Re: DMC Passive Gas Vent

See below for rough sketch of the temporary passive gas vent we are discussing at DMC.

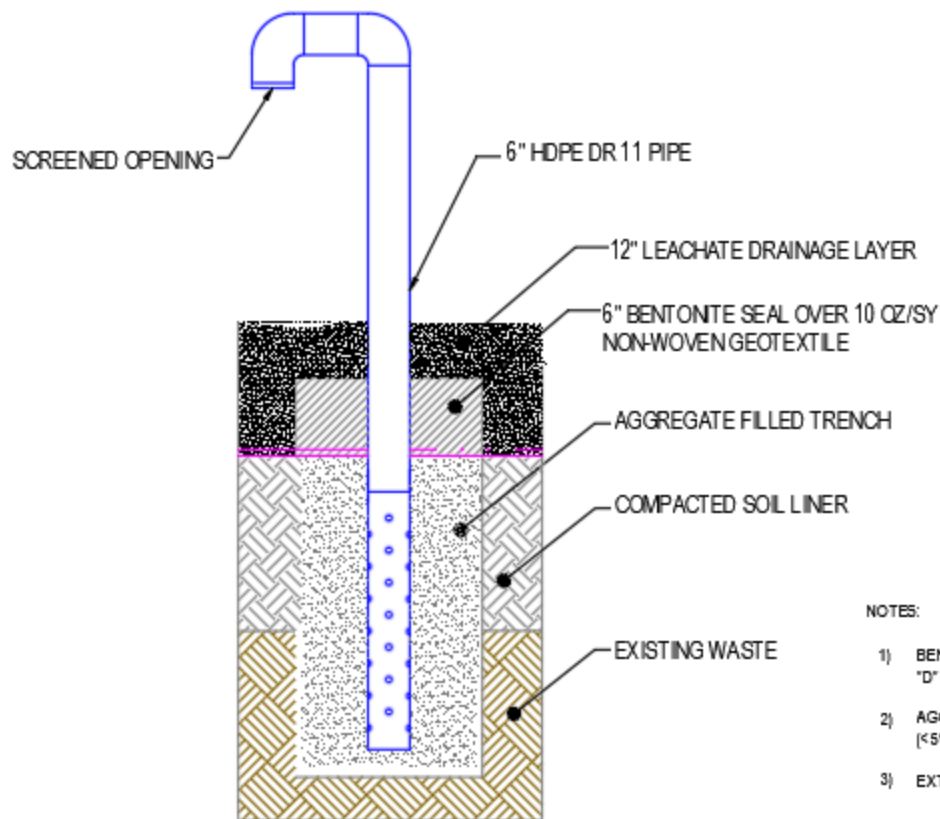
Per our conversation, the DNR concurs with installing one or more temporary vents to address 'whaling' of the liner in the upper portion of the newly constructed abutment liner. Although the proposal is to boot this temporary penetration, the DNR will not require an FML boot as long as waste is not placed upgradient (i.e. where leachate could flow to and down through the penetration). The DNR requests that a simple letter or email construction report (and signed by a PE) be submitted to document completion of this work.

Prior to placement of waste upgradient of the penetration, the temporary vent(s) shall be removed, bentonite plugged, and the FML repaired.
